File No. 12-99-702-SI

SUBJECT: WORK PLAN ADDENDUM
15595 Washington Avenue, in
San Lorenzo, California A

As agreed, we would like to amend our September 2004 work plan and June 2005 addendum in accordance with our recent site meeting. This addendum addresses 1) revised boring locations; 2) addition of CPT borings; 3) reduction in the number of proposed monitoring wells; 4) use of an on-site mobile laboratory; 5) deferment of domestic water well sampling; and 6) permit procurement.

WELL DETAILS

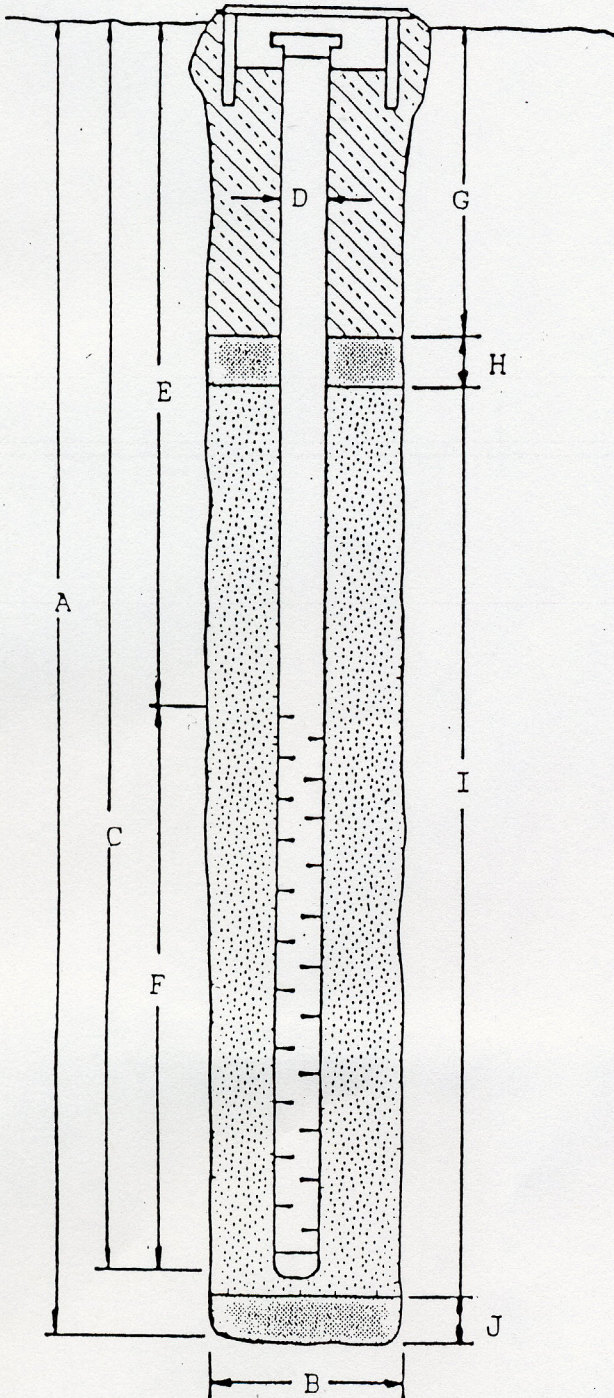
After the Geoprobe and CPT samples have been analyzed and interpreted, a hollow-stem auger drilling rig will be mobilized to the site and used to install monitoring wells. Our previous work plan called for the installation of seven or eight new wells; however, after visiting the site and identifying viable drilling locations, the number of wells was reduced to three. Depending on the results of the CPT borings, the wells may be clustered wells screened in two water-bearing zones.

The screen length in each water-bearing zone will be 10 feet, to insure that the sampling results are representative of hydrocarbon concentrations near the top of each zone. Figure 2 shows the proposed construction of the monitoring wells.
